2009-01-02

Milford School District

Figure 1: NRCS soil survey update mapping in the vicinity of the Milford Upper Elementary School.

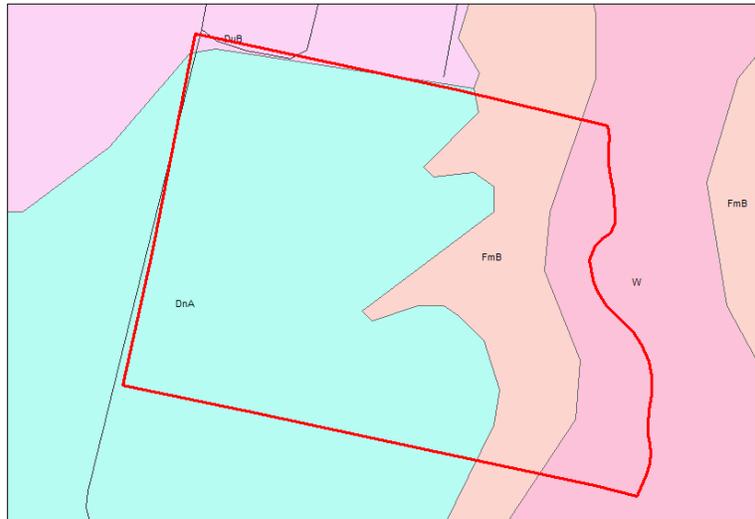
Soils Assessment. According to the NRCS soil survey update Downer (DnA; 0-2% slopes) and Fort Mott (FmB; 2-5% slopes), and Water (W) were mapped on subject parcel. Downer and Fort Mott are well-drained upland soils that, generally, have few limitations for development. The area mapped as water also includes wetlands and is unsuitable for development (Figure 1).

Figure 2: SWMP mapping in the vicinity of the Milford Upper Elementary School.

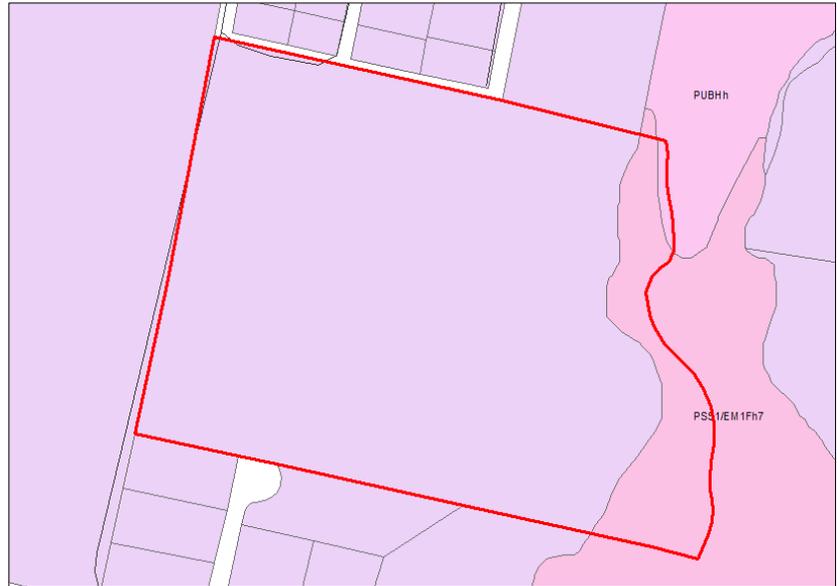
Wetlands. According to the Statewide Wetlands Mapping Project (SWMP) maps palustrine scrub-shrub/emergent riparian wetlands (PSS1/EM1Fh7) and palustrine unconsolidated bottom (PUBHh; diked pond) bottom wetlands were mapped on subject parcel (Figure 2).

The applicant is responsible for determining whether any State-regulated wetlands (regulated pursuant to 7 Del.C. Chapter 66 and the Wetlands Regulations) are present on the property.

This determination can only be made by contacting the Division of Water Resources' Wetlands and Subaqueous Lands Section at 302/739-9943 and consulting the State's official wetland regulatory maps, which depict the extent of State jurisdiction. The area regulated by State law may be very different from the area under federal authority.

No activity may take place in State-regulated wetlands without a permit from DNREC's Wetlands Section.
